UNITED STATES PATENT AND TRADEMARK OFFICE

| APPLICATION NO. | FILING DATE | FIRST NAMED INVENTOR | ATTORNEY DOCKET NO. | CONFIRMATION NO. |
|--|-------------|----------------------|---------------------|------------------|
| 10/589,973 | 08/18/2006 | Koichi Hirano | 062853 | 2378 |

Office Action Summary

DETAILED ACTION

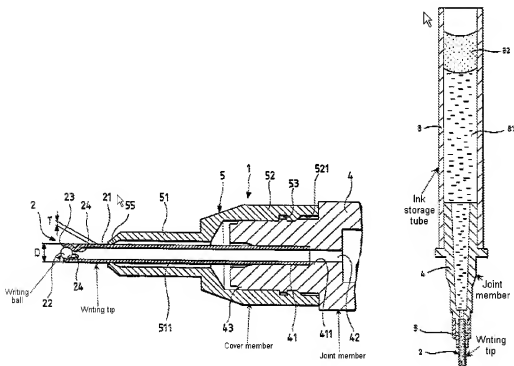
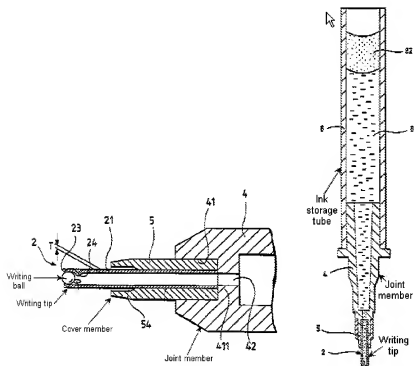
Regarding claim 1, Sekine discloses a ball-point pen having a writing tip which rotatably supports a writing ball, an ink storage tube of which ink is stored, a joint member, and a cover member fitted and mounted along the perimeter surface of the joint member (*see annotated figures above*). Even though Sekine does not specifically disclose that the cover member is arranged in dimensions so as not to approach within 0.2 mm of the writing tip, it, however, would have been obvious to one of ordinary skill in the art at the time the invention was made to use such optimum value since simply

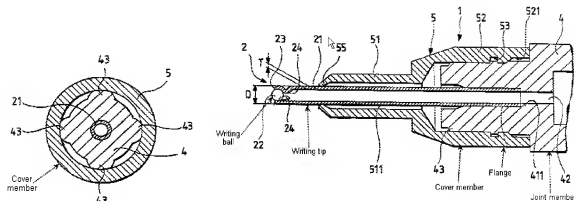
Regarding claim 7, Sekine discloses the cover member is formed into a cylindrical shape and includes a flange formed at one end of the cylindrical portion; the flange coming into contact with an end of the joint member (*see annotated figures below*).
